SERVICE BULLETIN

MODEL(S): Sun Bicycles - Shortcut Folding Bikes

FRAME JOINT QUICK-RELEASE ADJUSTMENT

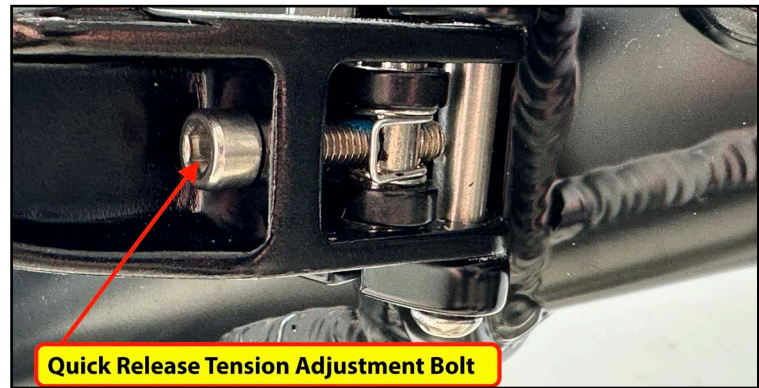
The tension adjustment bolt on the frame joint quick-release mechanism, hereafter referred to as QR & QR-Adjustment Bolt can come out of adjustment when left in the open position, such as when transporting the bike in the folded position. To remedy this, replace the original QR-Adjustment Bolt with our updated version, p/n 881011, which includes applied Loctite on the threads to prevent accidental rotation of the QR-Adjustment Bolt. Any rotation, clockwise or counterclockwise, will affect the QR tension. The rider should check the QR tension on the frame joint and inspect the frame for any signs of cracking before each ride. Failure to maintain adequate QR tension at the frame joint can damage the frame and QR mechanism.

1. Remove the original Quick-Release Lever Tension Adjustment Bolt
2. Replace with the updated Quick-Release Lever Tension Adjustment Bolt which has applied Loctite on the threads. **IF ASSEMBLING A NEW BIKE, CHECK BIKE CARTON FOR NEW HARDWARE PACKET**

- P/N 881011 - Folding Frame Quick-Release Lever Tension Adjustment Bolt with applied Loctite
